# Extension to Listed Gate Lodge at Armitstead

Armitstead Child Development Centre, 94 Monifieth Road, Broughty Ferry

## SUMMARY OF REPORT

Figure 3 – Gatehouse

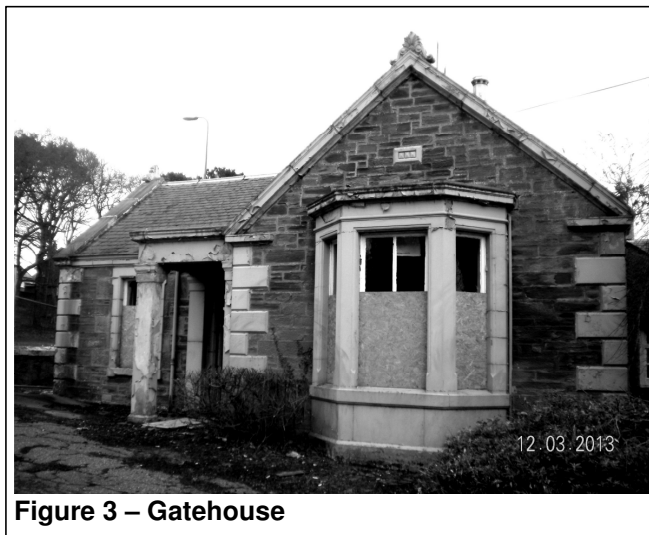
2.3 Immediately adjacent to the entrance sits the Category C listed gatehouse which is a late Victorian property built as part of a wider estate encompassing Armitstead House (see Figure 3). The property is currently unused and appears to have been this way for several years. The building itself is showing significant signs of distress generally from wear and tear and misuse, however, there are additional signs of damage due to water penetration. This has further been exacerbated from what appears to be a lack of maintenance of the property in recent years.

2.4 The construction of the lodge is fairly typical of its time. Wall construction is sandstone formed from snecked rubble with painted margins to all openings and chamfered rusticated quoins to corners. The elevation treatment is enhanced by the use of expressed gables with pediment features and entrance porticoes to break up the overall scale of the building. Windows are typically single glazed timber sash and case (painted white). The roof is finished in slate throughout.
